### **Product Change Notice (PCN)**

PCN Number: PCN-0451317R-01

Product(s) Affected: PD-30S and PD-40S

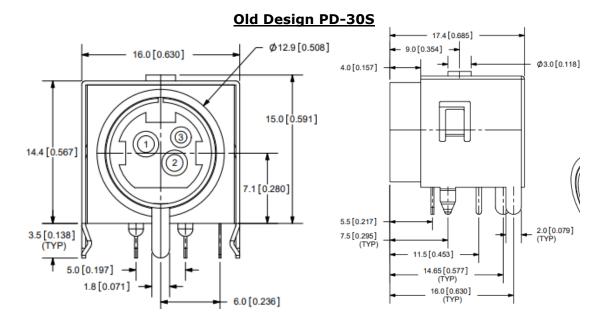
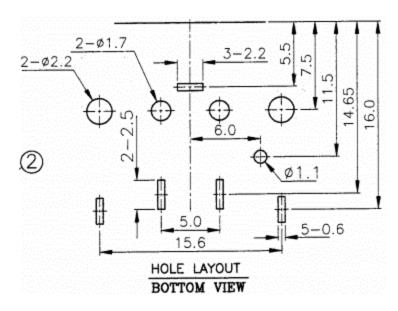
**Description of Change:** Housing and PCB layout changes as shown below.
